Appl. No. 10/803,295 Amdt. Dated 3/28/2005 Reply to Office Action of 12/28/2005

AMENDMENTS TO THE DRAWINGS

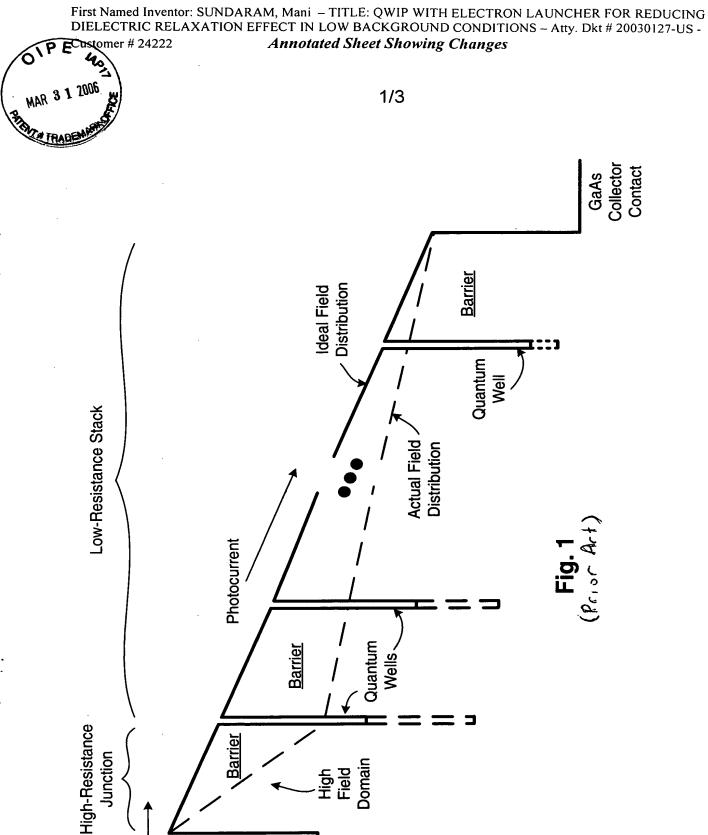
The attached sheet of drawings includes changes to Fig	1	this	s sheet, which includes Fig
1, replaces the original sheet including Fig. 1. In Fi	ig	1	, previously omitted
legend "(PRIOR ART)" has been added.			-
